SERVICE BULLETIN

Date: APRIL 14, 2011
Log Number: 124
Models Affected: GL-C / GW-100
Subject: SPRAY ARM CLIP

SPRAY ARM CLIP

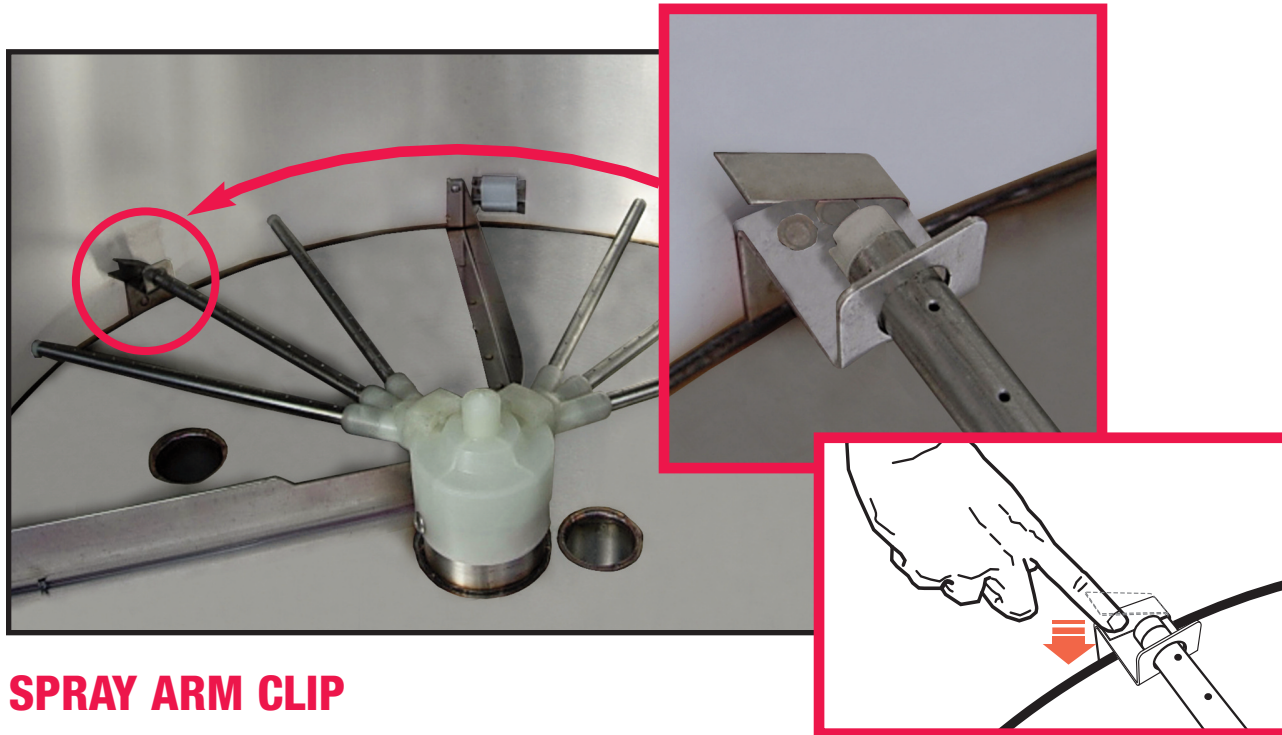
CMA has added a feature to the GL-C and GW-100 lower wash arm. The feature is a “Wash Arm Clip” to prevent spray arm from separating from the lower spray base if subjected to higher wash pressure or a worn securing o-ring.

Press down on clip to release spray arm.
